MEETING AGENDA

Appearance Commission

Village of Homewood

A. **Public Meeting** for Case 25-28: Appearance Review for Target, 17605 Halsted Street

1
G300
PROPOSED SITE PLAN
NOT TO SCALE

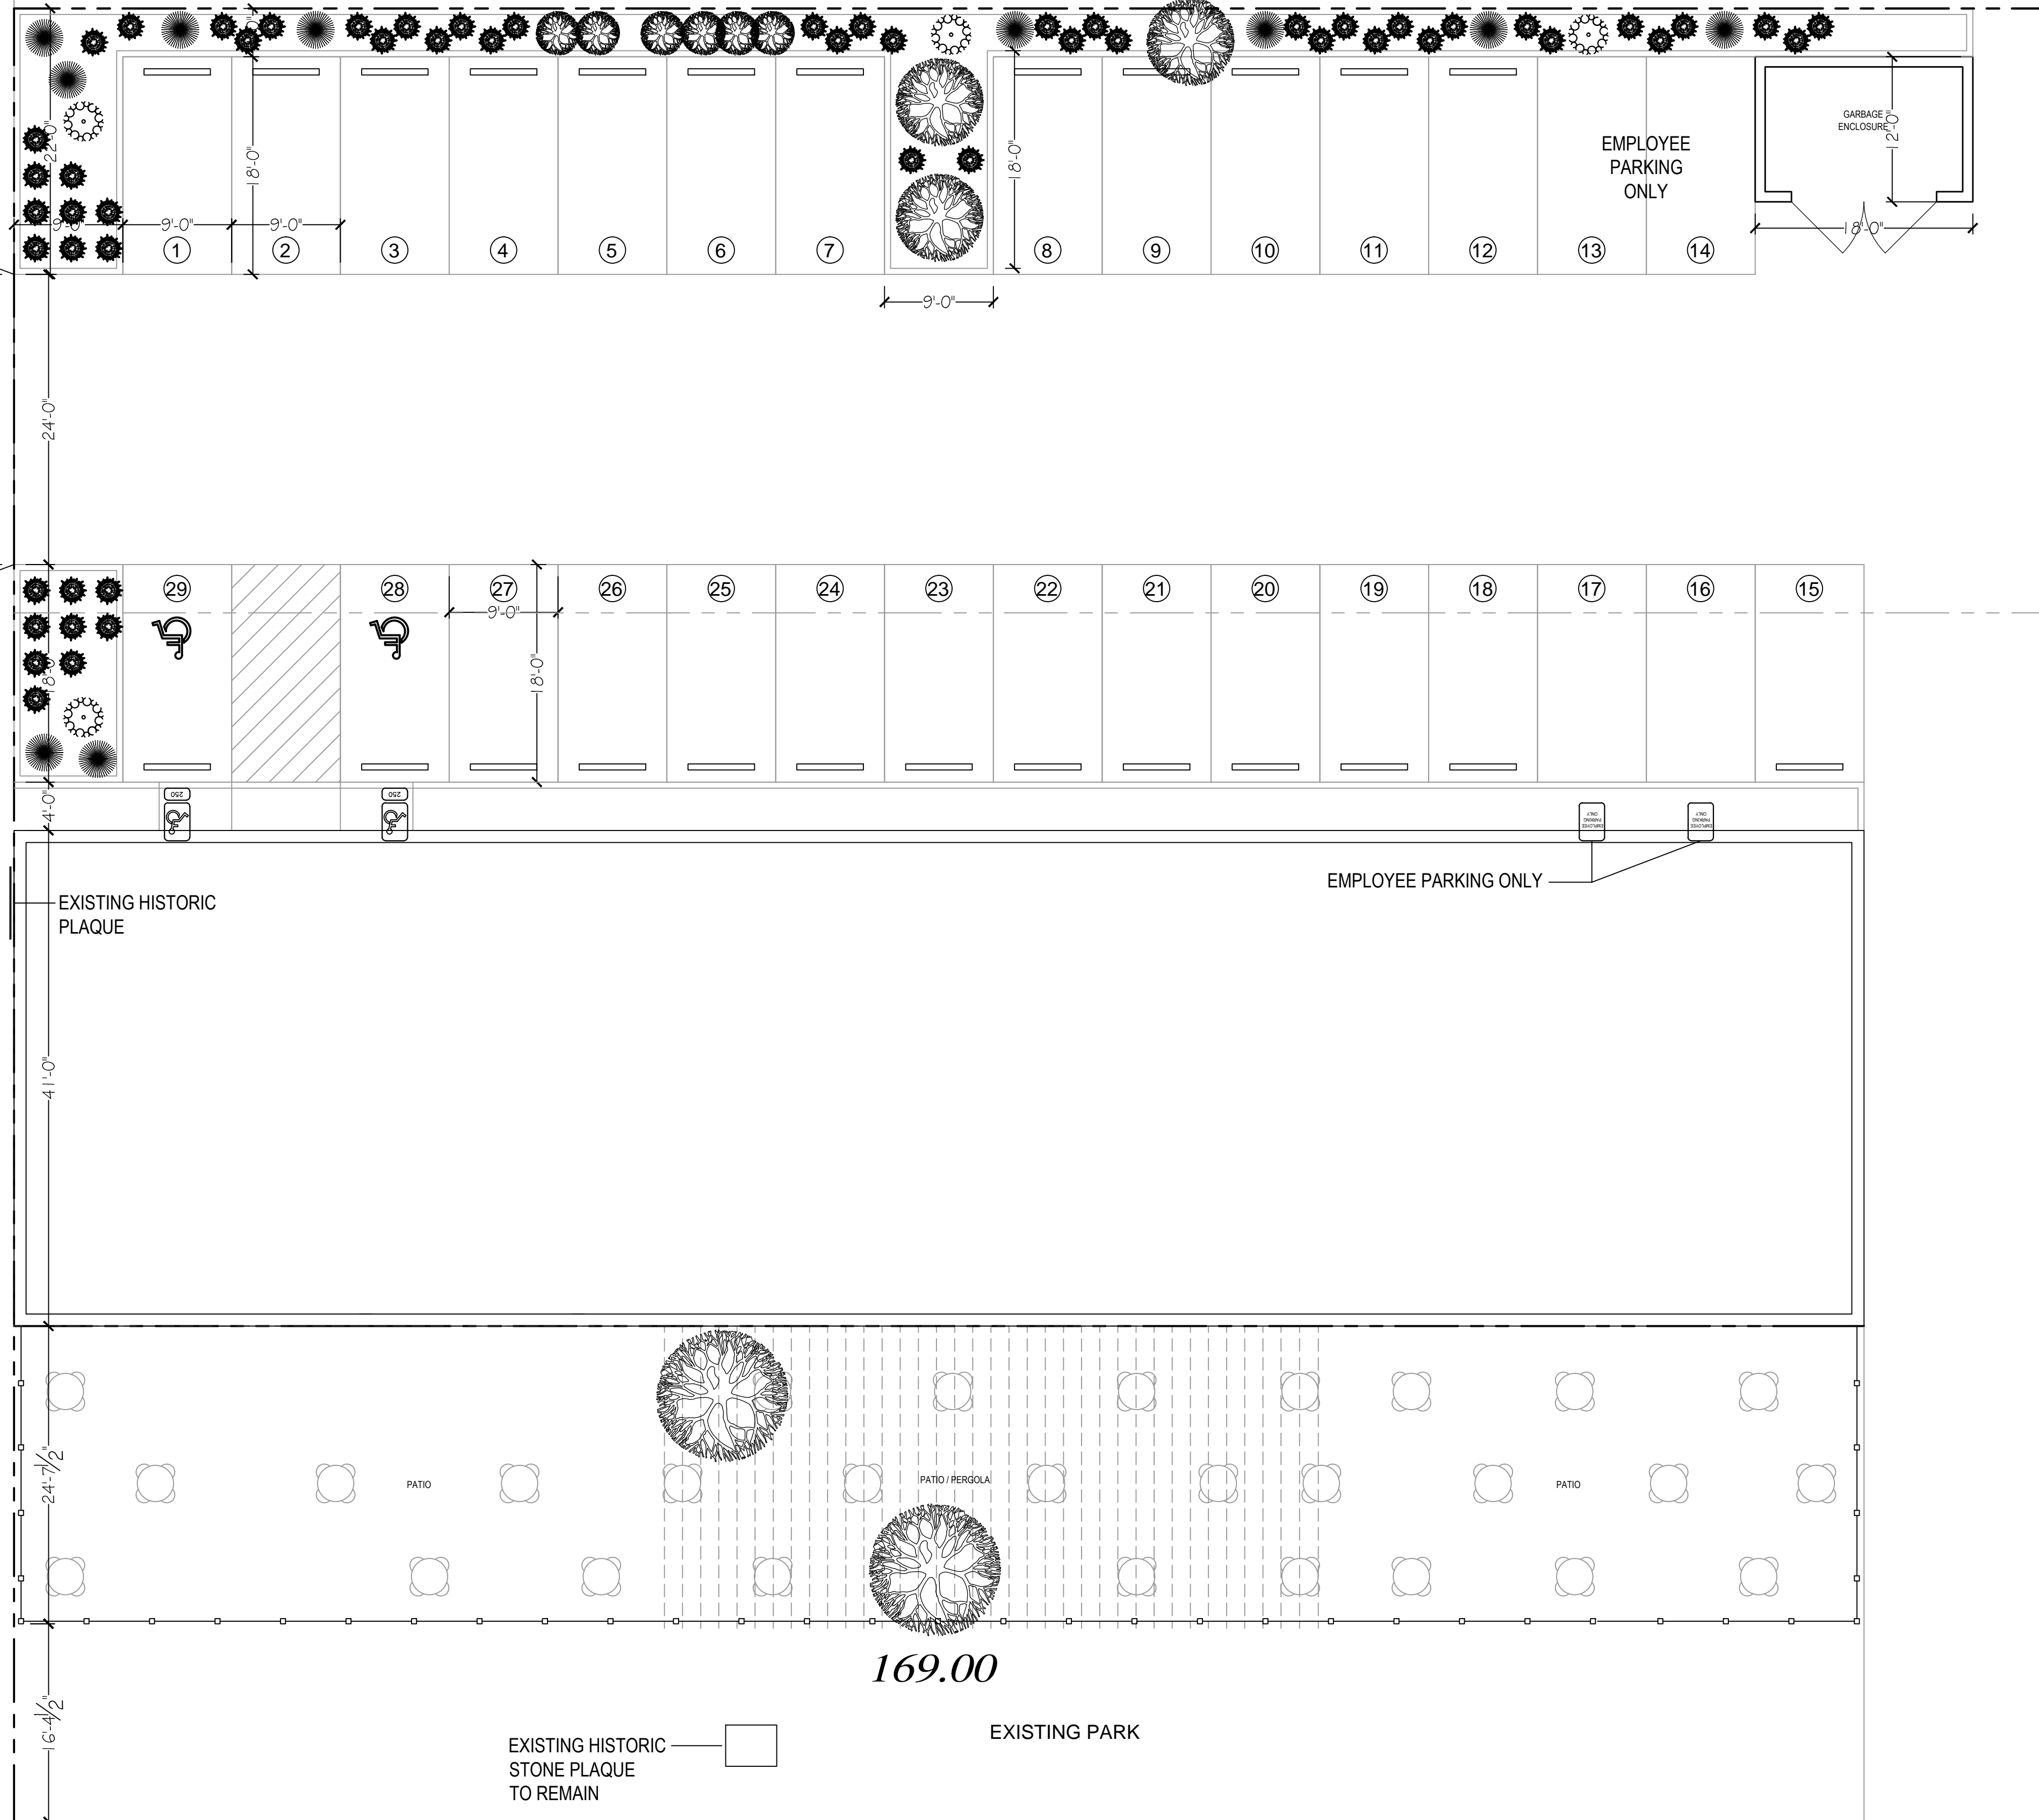
- 3. Parking Island:** Move the existing parking island to a location adjacent to the trash enclosure to provide screening for the enclosure, which meets Zoning Ordinance requirements (Section 44-08). *Staff recommends that Appearance Commission approval by conditions upon the movement of the parking island, the parking space closest to the proposed enclosure.*

- 4. Landscaping Materials:** Replace landscape materials as agreed to with the Village Arborist, including the following recommended replacements (as appropriate):

PROPOSED
ELEVATIONS

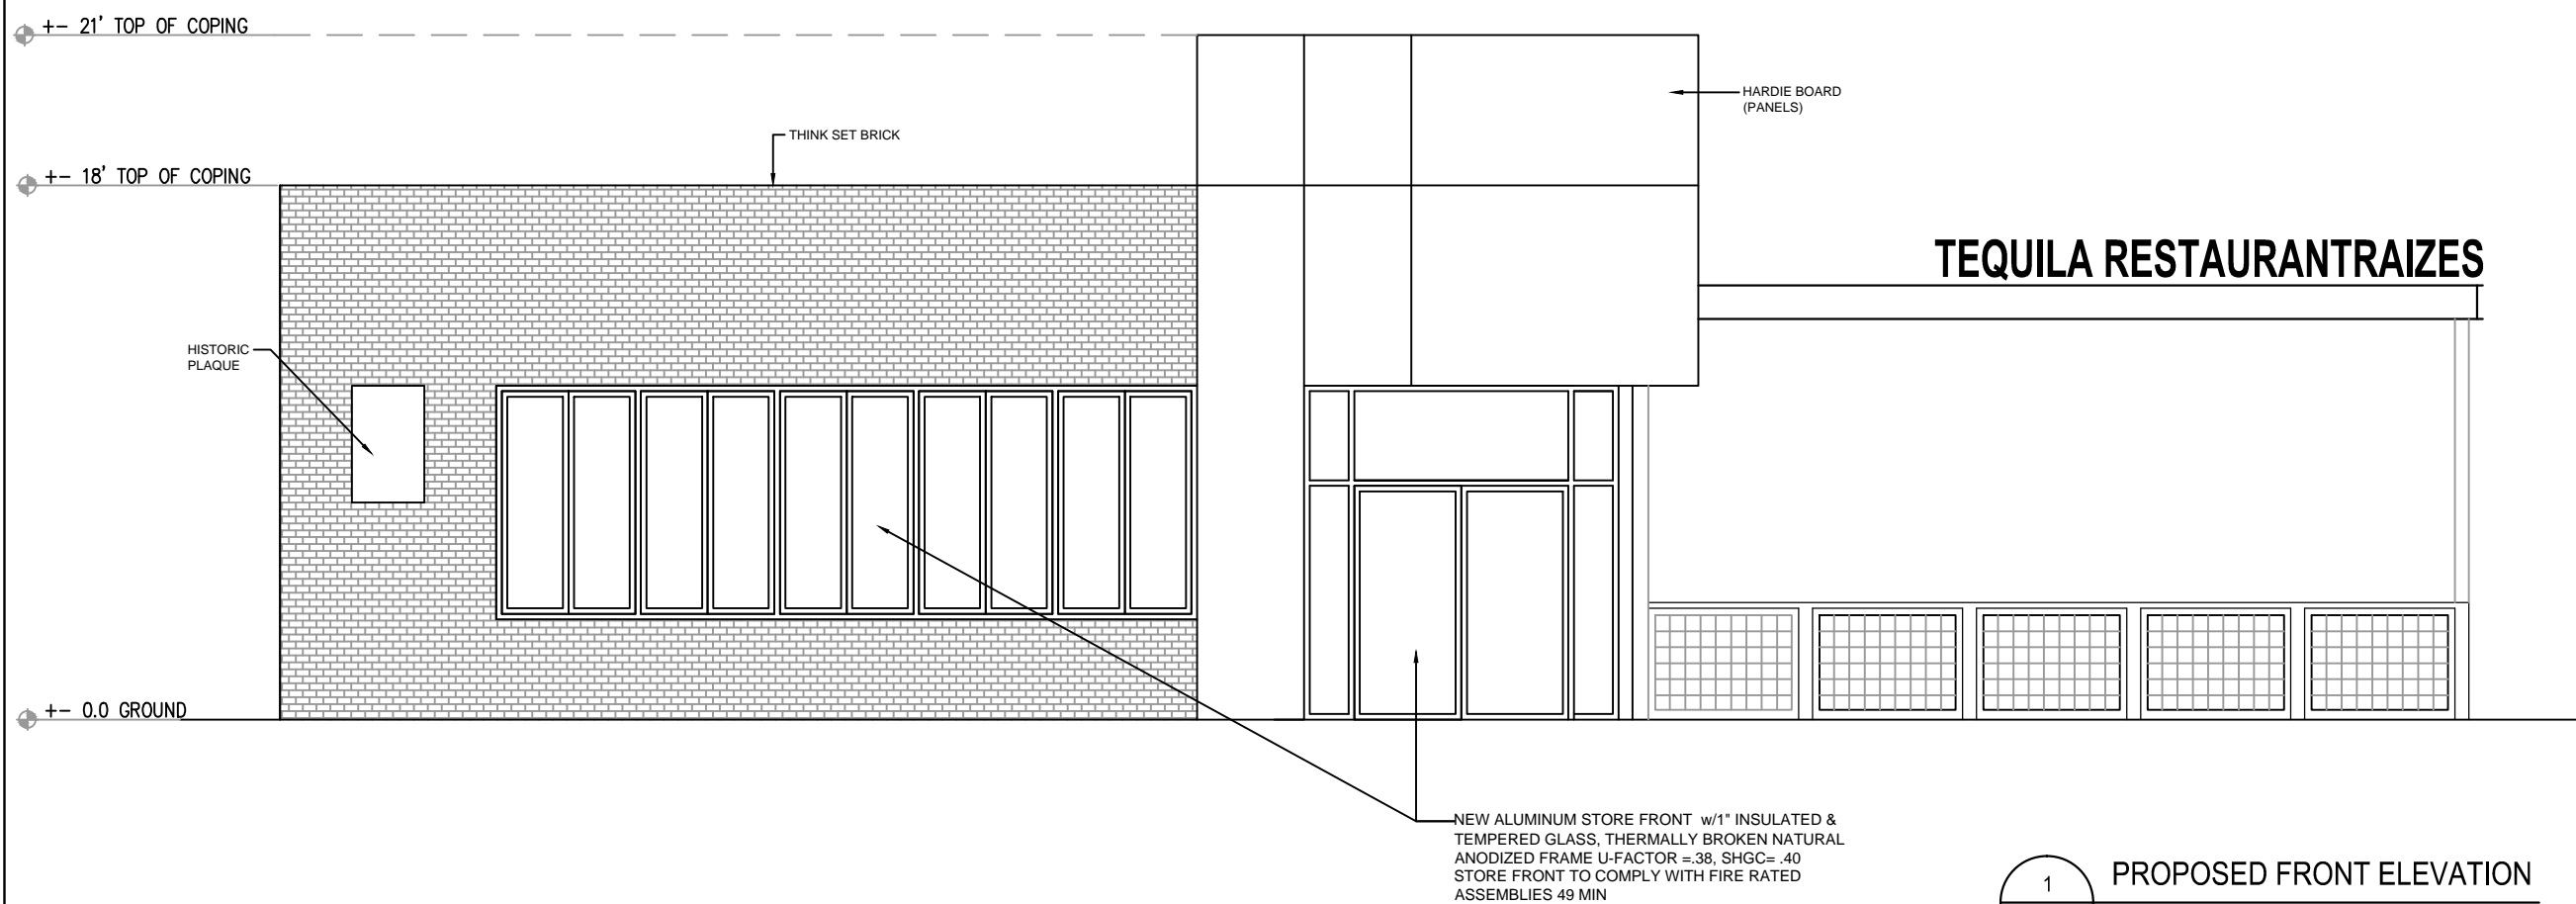
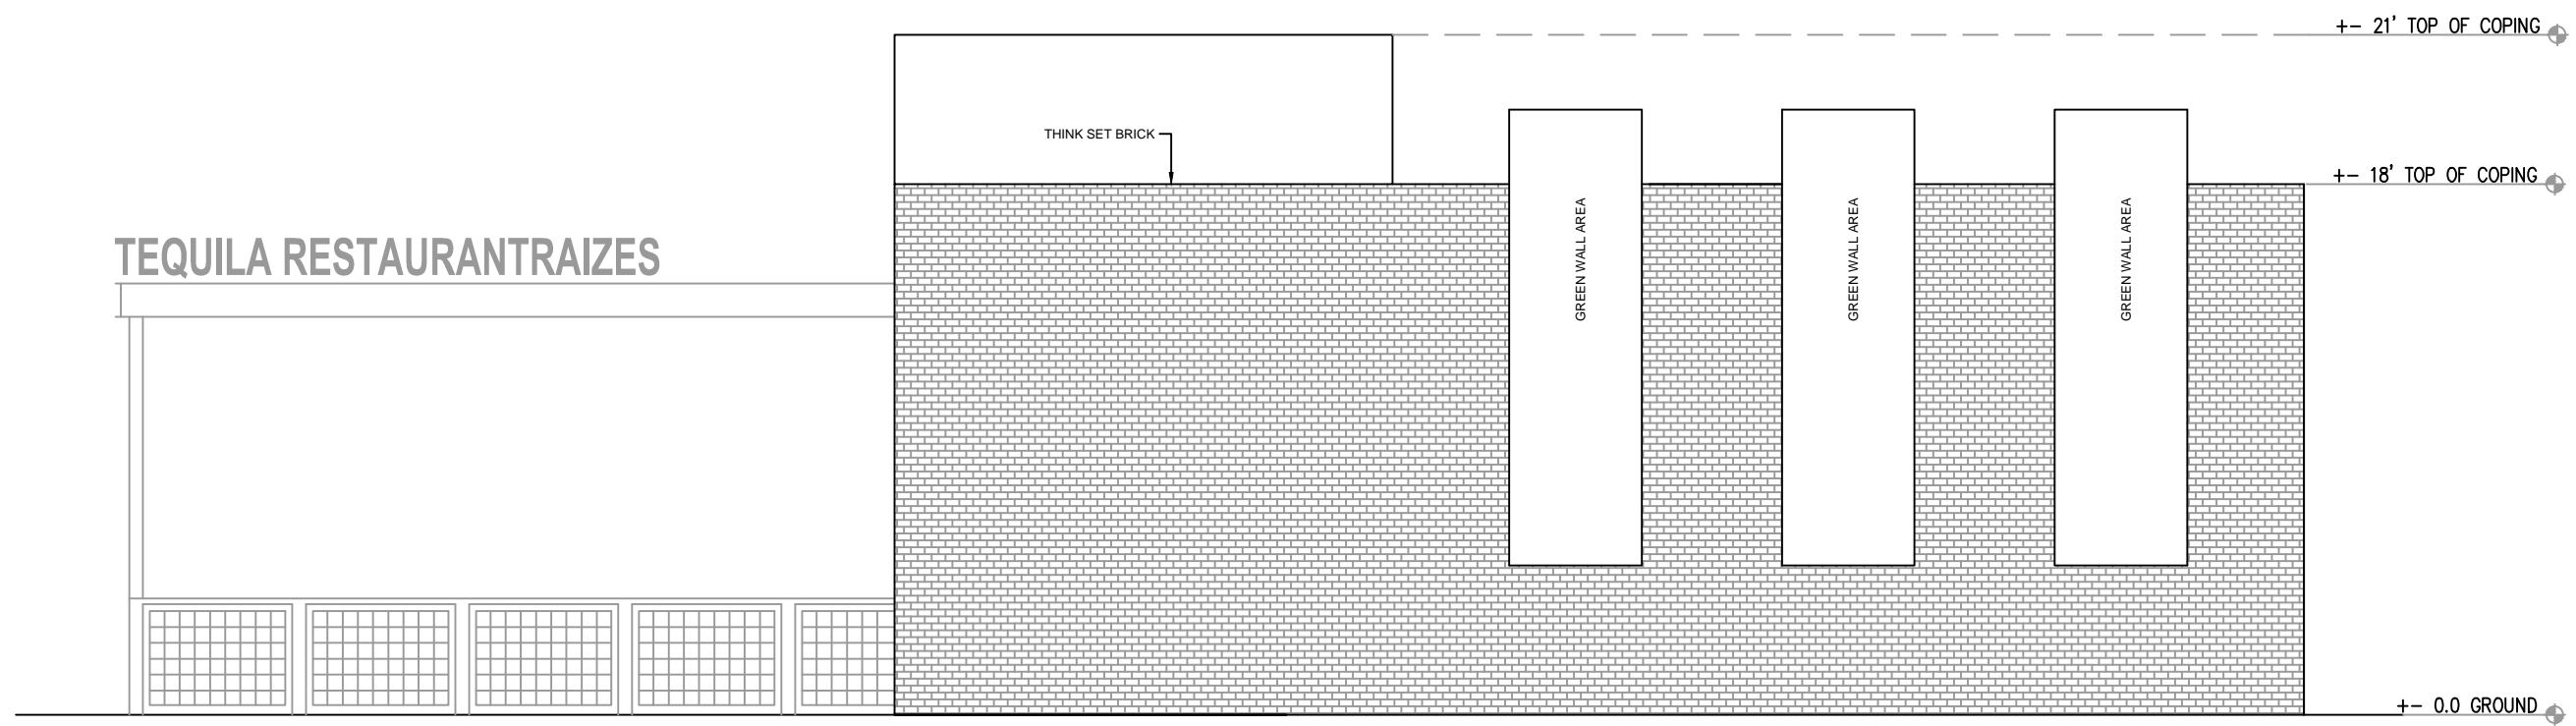
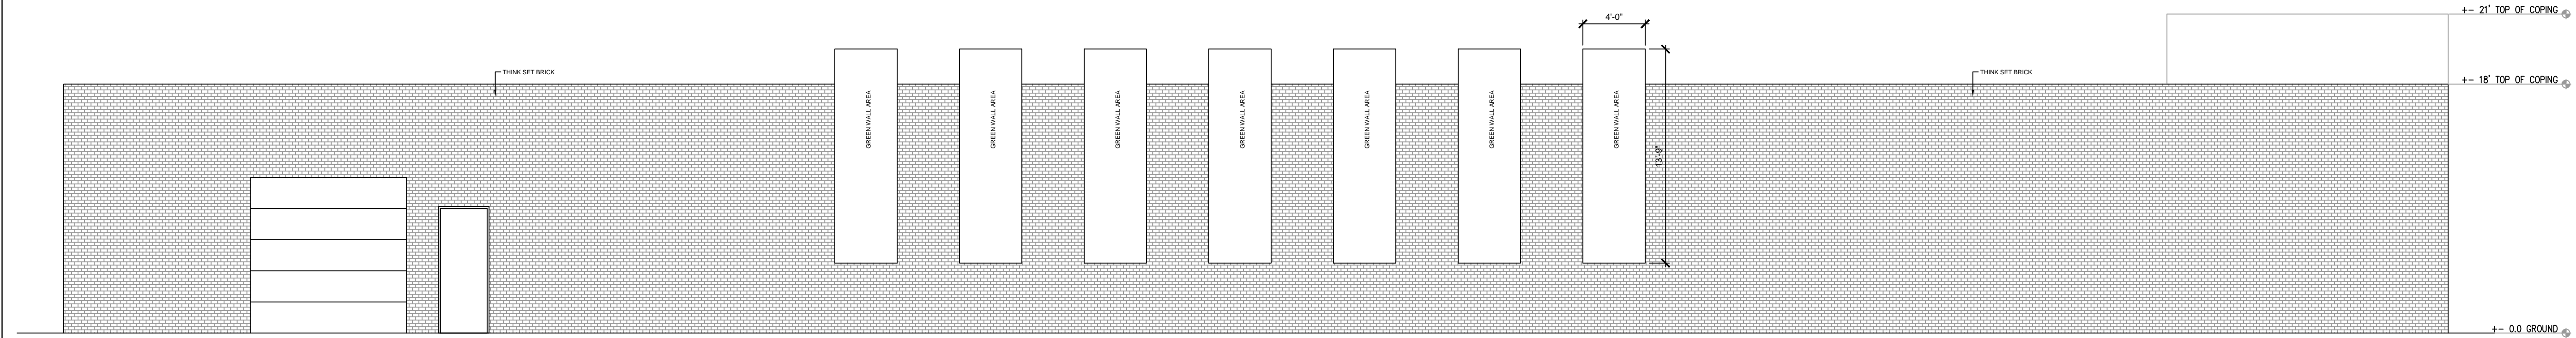
5. **Green Panels on South (Side) Elevation:** Add two green panels and shift all panels approximately 20-30' toward Dixie Highway to add façade articulation closer to Dixie Highway where the building is visible from the public right-of-way.

6. **Green Panels on West (Rear) Elevation:** Remove three green panels and move to blank wall area on north (exterior side) elevation, near the northwest corner of the proposed building.

7. **Brick Color:** Change proposed color of smooth-face brick material from black to a warmer tone compatible with surrounding buildings along Dixie Highway. Recommended to replace color with dark brown brick similar to that used on Homewood Brewing Company (18225 Dixie Highway) and neighboring condominium buildings (18133 Martin Avenue), or another color as recommended by the Appearance Commission.

8. **Parapet Walls:** Identify rooftop equipment height on final plans and provide a brick parapet wall suitable for screening any equipment.
9. **Lighting:** Submit a photometric plan before final approval, and identify all lighting (including string lights on patio and other recommended features) on the final plan.
